# PRODUCTION INSTRUCTIONS

## BATTERY MODULE PCBA

**Date:** 10-7-2020  
**Revision:** 1.0  
**Author:** Tony Little  
**Product:** Electric Skateboard  
**Company:** Globe Brand

### 5.1 COMPONENT PLACEMENT

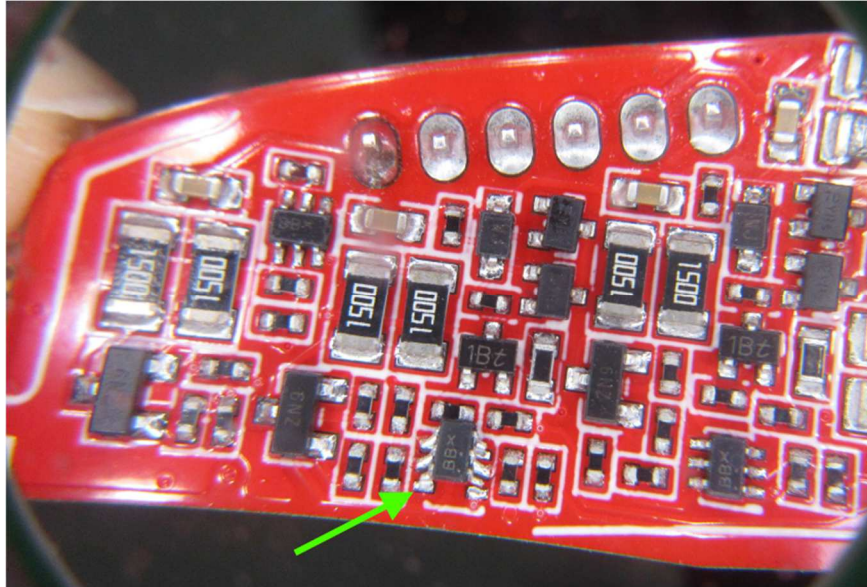
Component T3\_B2 (SOT363) was mis-aligned to same effect for several boards.

## 5.3 TINNED WIRING

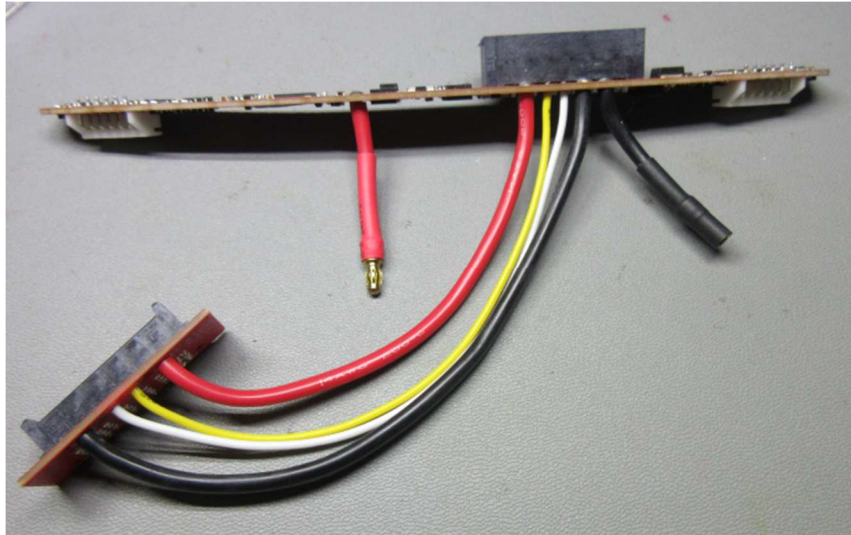
Union supplied wiring. Tinned ends had insufficient stripped length. Kenly advised Union need to revise stripped length to 2.5mm.

### 6.1 IC9

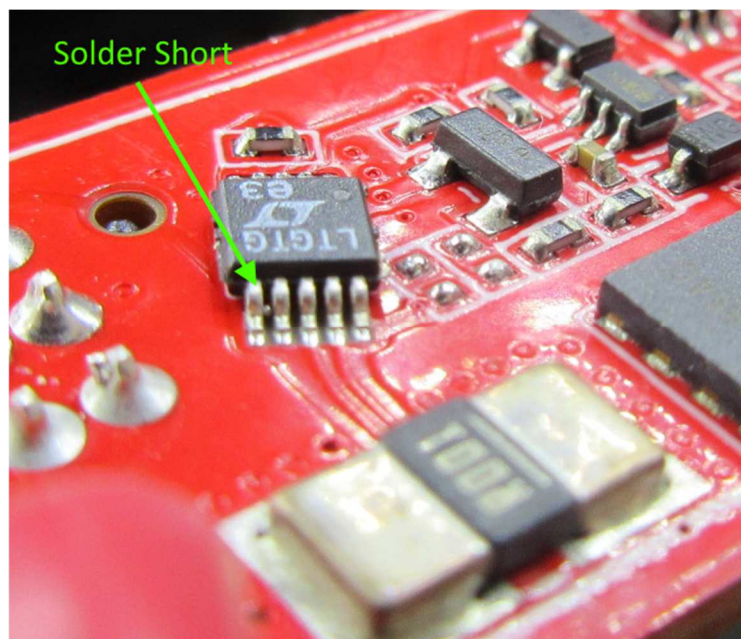
A low number of IC9 (LTC4368IMS-1#PBF) failed initial testing. Only 1 was found with a solder short. There is some concern two reflow cycles and two wave soldering cycles may have contributed to the device failure prior to use.
